Technical Assessment

Handling of Untreated Incinerator Bottom Ash

At the Planned Powerfuel Portland Incinerator Plant

Isle of Portland, Dorset

Figure 2: Location of proposed storage of unprocessed incinerator bottom ash, outside of the application boundary

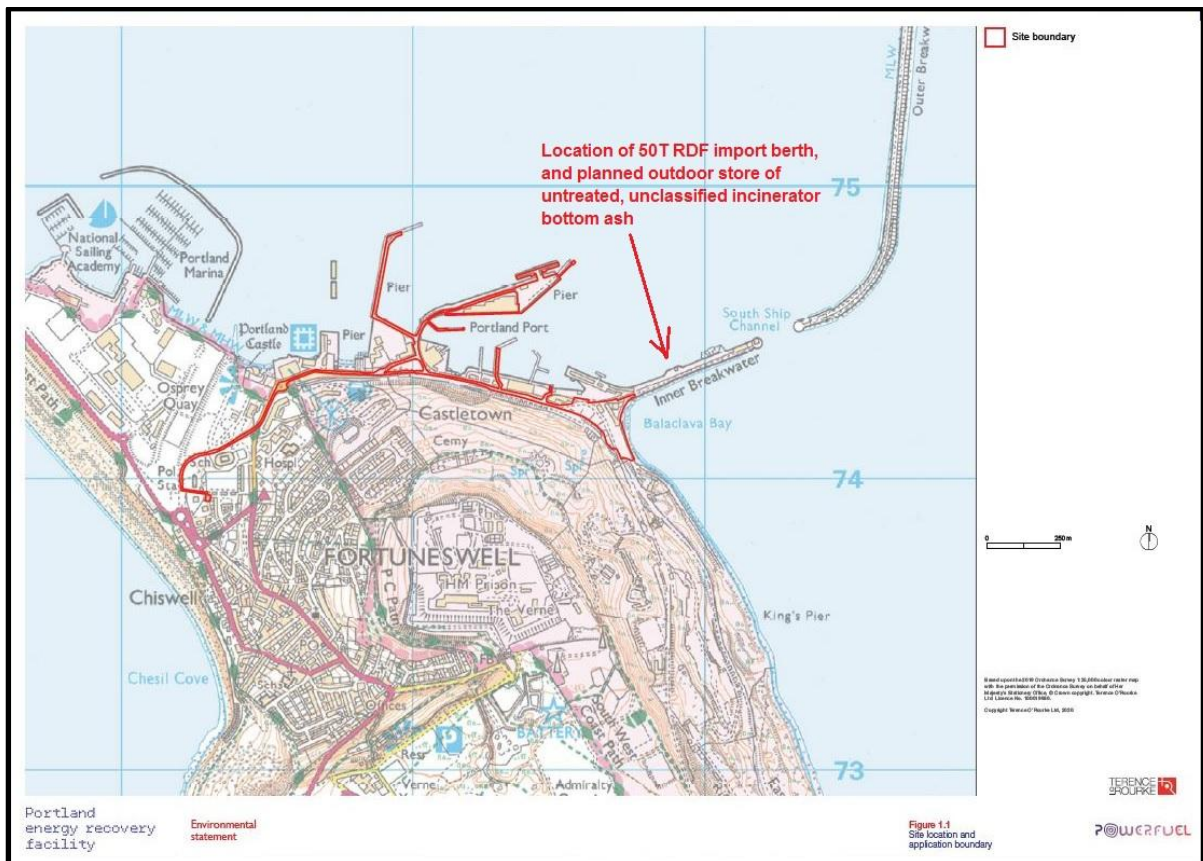
Box 5: This statement refers to the suspected “dedicated storage area” for the potentially uncategorised uIBA waste. The “grab machine” being that of a “geared ship” discussed later, moored alongside the “steel container” or lighter anchored at the “50T RDF berth” in the PfP publicity literature. Again, an open storage facility is a breach of planning policy. Figure 1 shows the “import berth”. Figure 2 shows how this lies outside the defined boundaries of the development site.

It can also be concluded that for this grab machine to function, the IBA will be tipped on the quayside into a bunker and/or transferred into the lighters for open storage, whilst awaiting collection by geared ship for transportation to Greenwich. Something alluded to later in 2.62

Figure 5: Dedicated area for untreated IBA quayside storage. Considering the available surface area, it is envisaged that any containment bunker would be temporary, used as a tipping point for material to be moved directly to the moored up lighters.

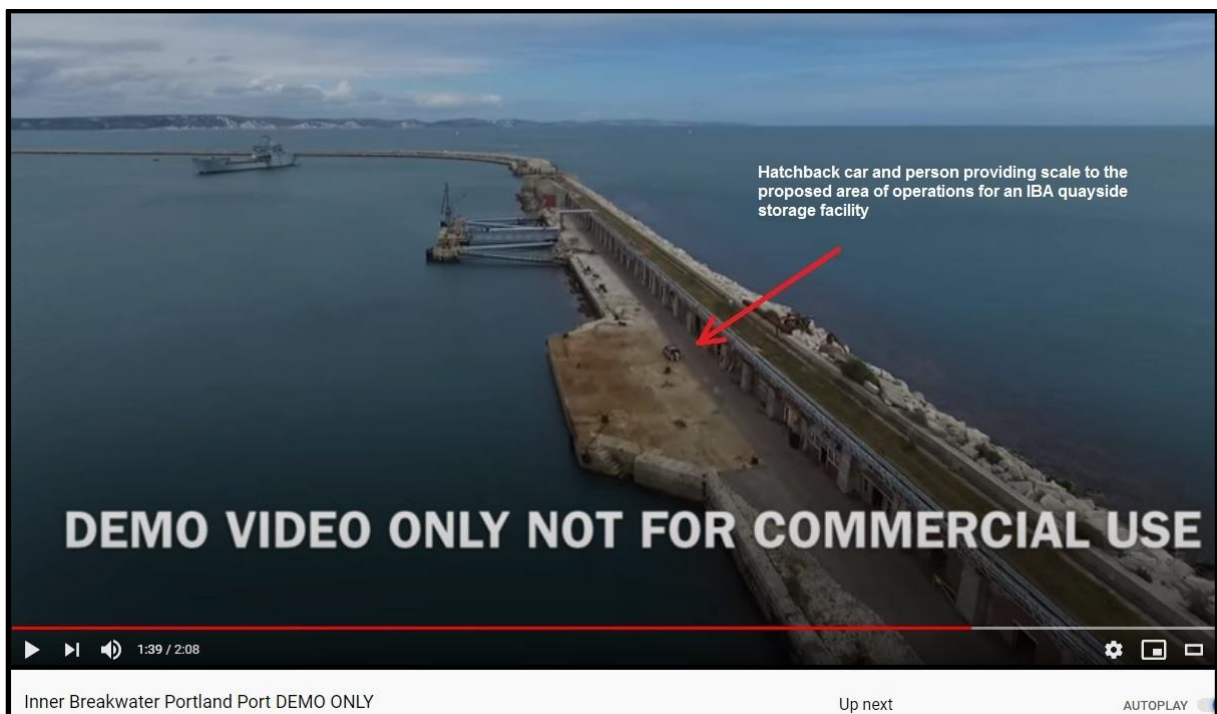
Box 11: Figure 5 above shows the location of the dedicated uIBA storage area. With a daily production of approximately 140 tonnes a day and an IBA bulk density of around 1.5 tonne/m^3 , a daily storage volume of $140 / 1.5 = 93.3 \text{ m}^3$ is required. As such, it would appear the existing area is insufficient to store such a volume of material, explaining PfP’s quoted intention of storing uIBA in the steel container/lighter/specialised vessel moored at this berth.

Obviously, the potential for contamination of coastal waters with heavy metals by this external handling and storage operation is significant.

Figure 6: Boundary of the planned drainage scheme. As can be clearly seen, this excludes the quayside uBA storage facility. Therefore, this area will be exposed to untreated leachate runoff directly into Portland Port, or existing drainage.

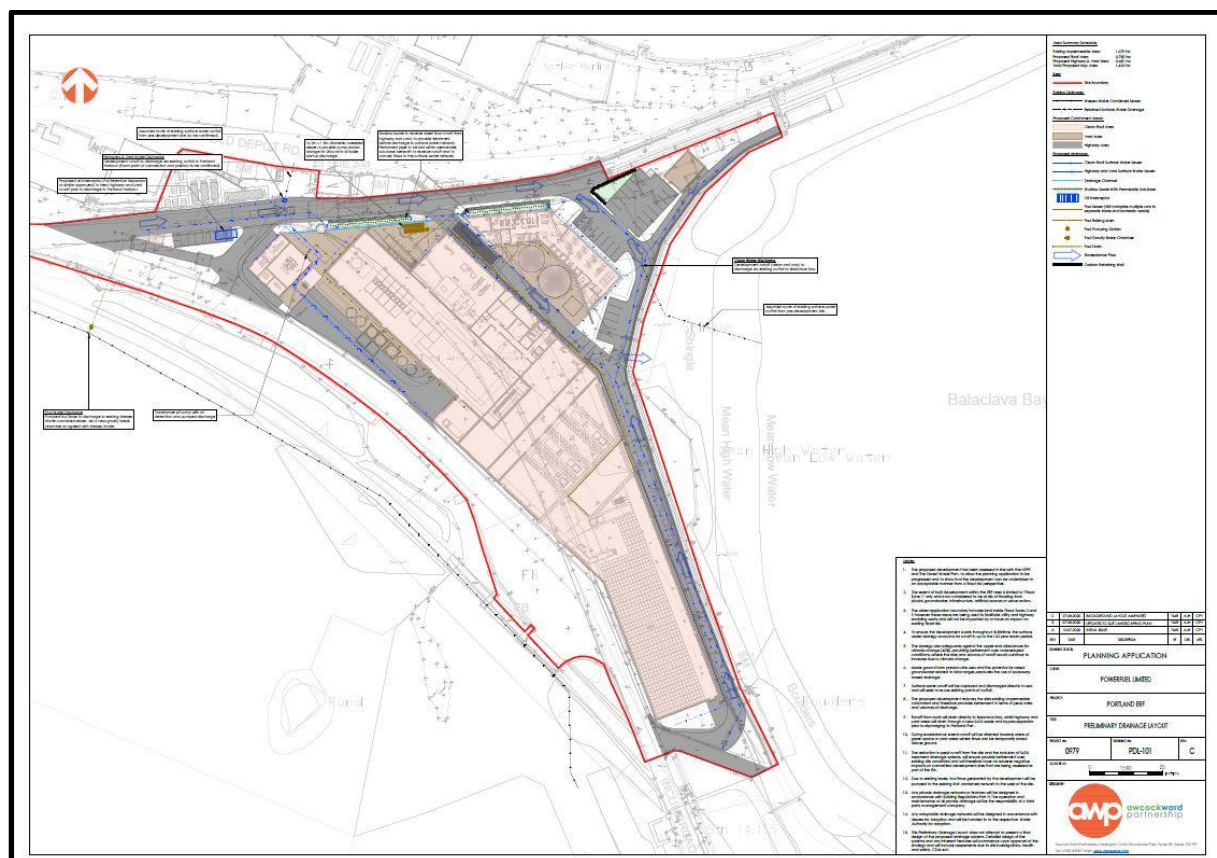
Box 12 Three points of notes with the drainage system should be recognised.

1. The quayside IBA store is not included in the drainage scheme
2. All roadway and yard waters, in addition to some roof run-off, is discharged into Portland Port. The only treatment is via sediment and oil traps. Neither piece of equipment is capable of separating heavy metal salts in solution due to leachate tracking and/or leakage, from surface water runoff. Instead, any contamination is simply “diluted” with fresh rainwater prior to discharge.
3. The IBA collection facility drains untreated IBA leachate directly into the foul drain

Figure 9: Highway and yard surface drainage within the service yard which may become contaminated by tracked uIBA leachate from the IBA collection area

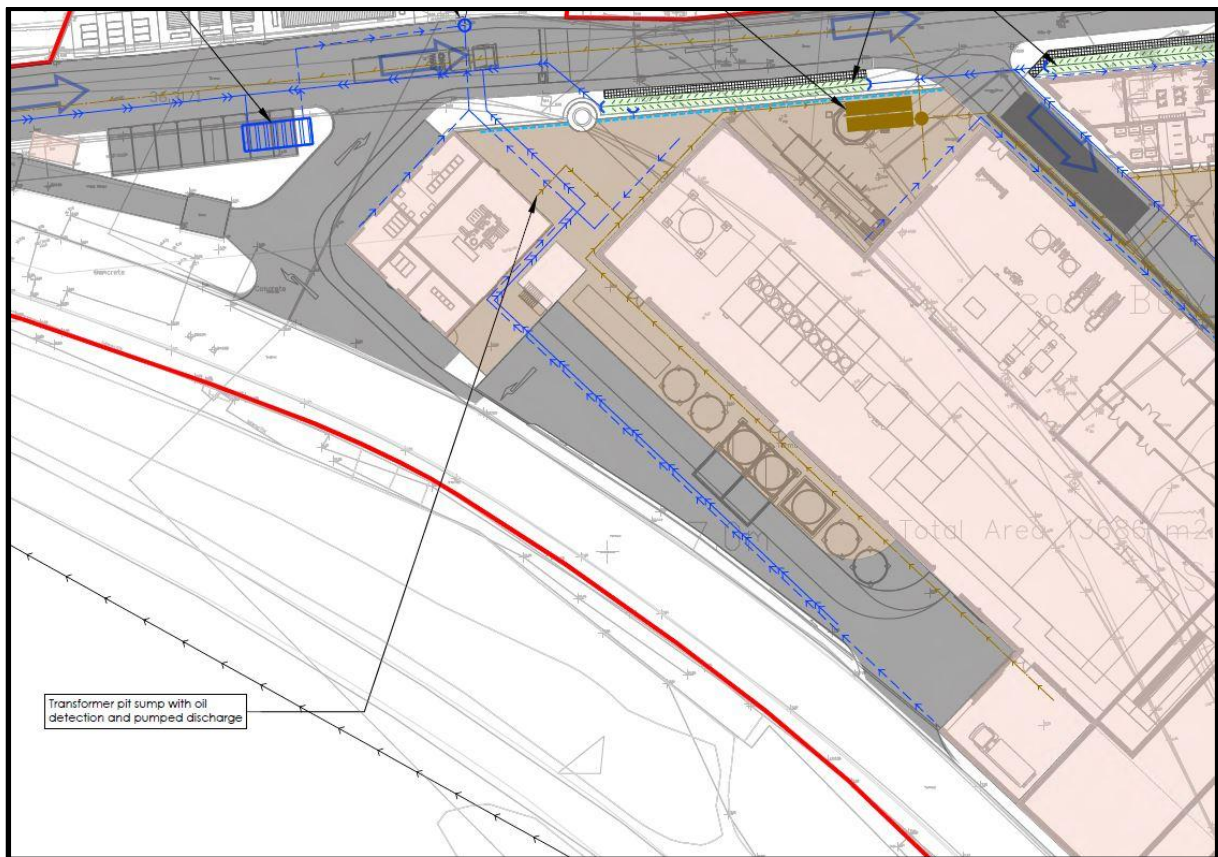
The IBA collection area drains into the foul water system (see 2.80). Tracking and leakage of uIBA slurry/leachate is foreseeable, within the service yard area and along the regular vehicle routes taken. Again discussed in 2.80 below.

Figure 10: IBA collection area showing foul water drain. This confirms the belief that in the absence of a sealed IBA hopper and re-circulating quench water system, pooling heavy metal leachate will be drained into the foul water system

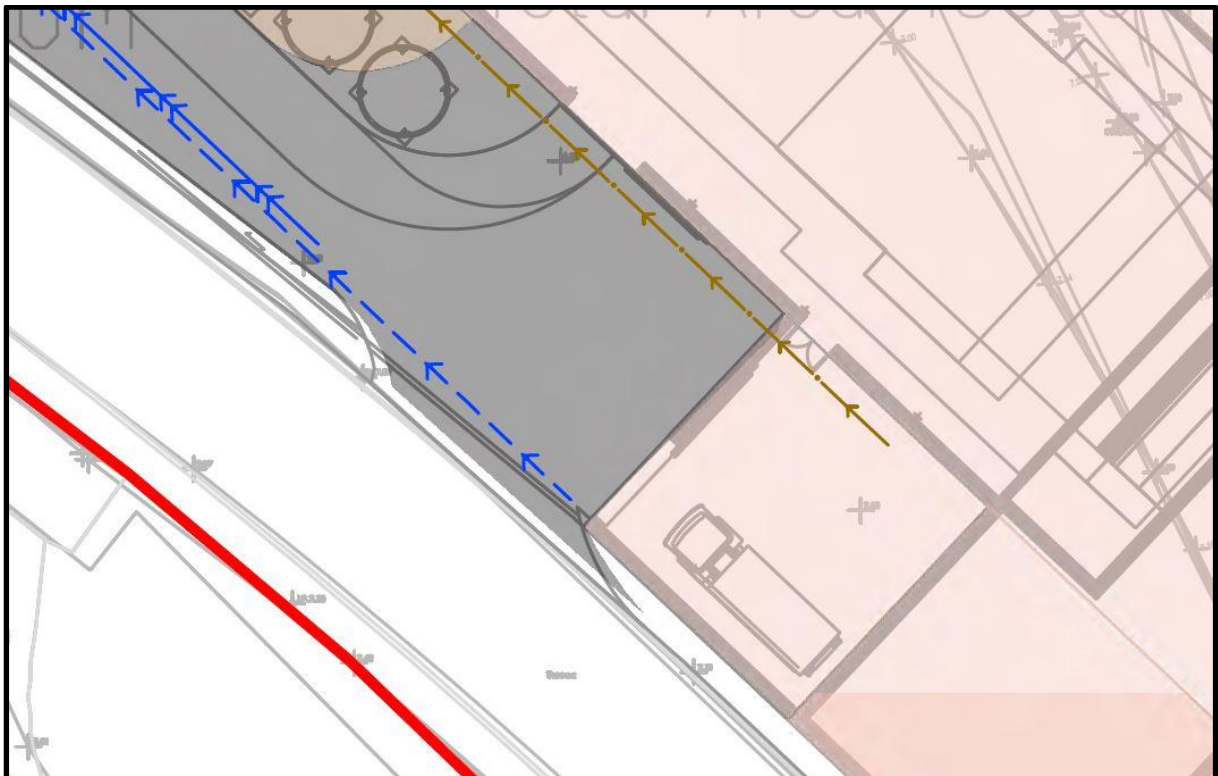
Box 3: Paragraph ES 2.40 detailed above defines the drainage system within the IBA collection area will discharge to an internal foul sewer, mixing with other internal foul waters prior to testing to confirm compliance with conditions of the effluent discharge licence imposed by Wessex Water. It should be noted that any such waters in the collection area will be a heavy metal leachate, not simple wash down waters. The uIBA within the covered collection area must be assessed to confirm the soluble heavy metal fraction prior to transfer off-site, either to the quayside or to Avonmouth. This is done via assessment of leachate.
